Technical Service Bulletin

Transaction No.: **2082837/1**

90 Service info: panoramic display: instrument cluster view changes after period during which vehicle is stationary

Figure 3. Panoramic display in left-hand drive vehicles (example; the layout is reversed in right-hand drive vehicles)

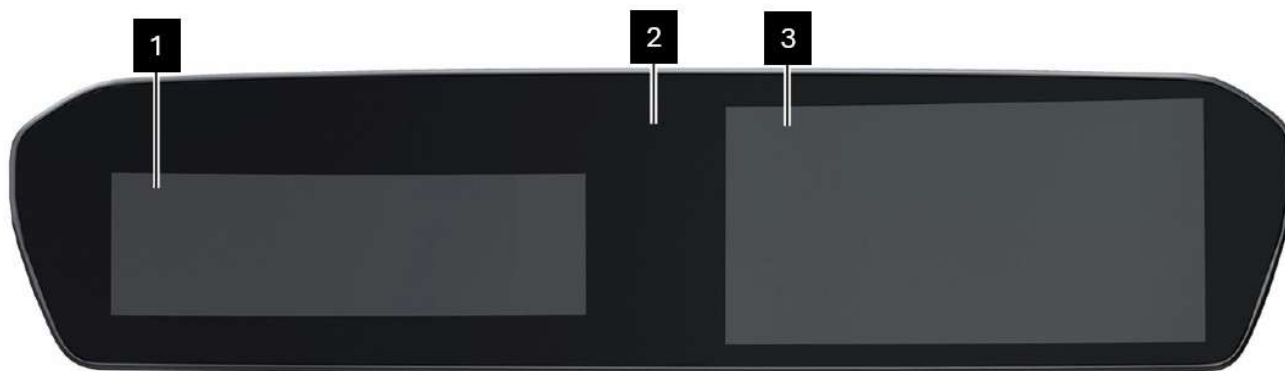
The instrument cluster (J1254, Figure 3) switches from the navigation map view (Figure 1) to the rev counter view (Figure 2) after a bus sleep cycle.

Instrument cluster view changes from navigation map to rev counter after bus sleep cycle due to design concept.

Design concept changed for model year 2027 with the introduction of a functional enhancement that takes into account the last instrument cluster view before a bus sleep cycle.
